## Product/Process Change Notice (PCN)

PCN #: PCN\_ConWTB254\_20160916

Product Affected: 6190xx11021 6190xx19521

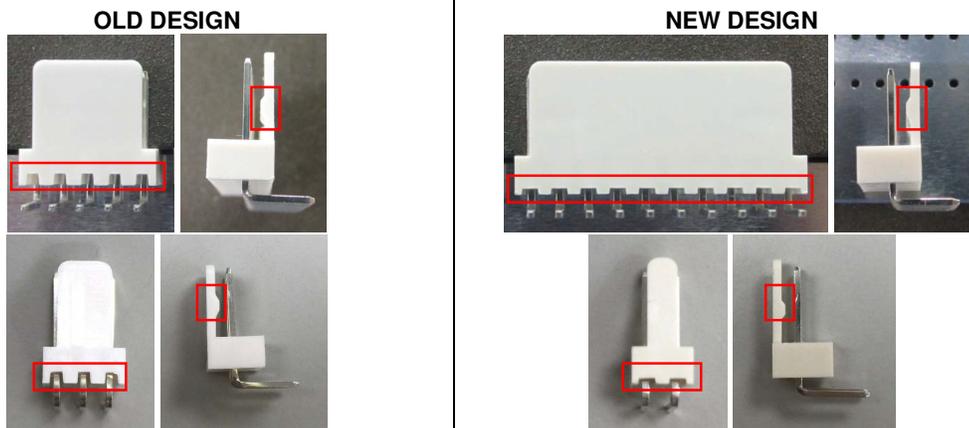
The plastic grooves are shallower, the locking tongue base is thinner.
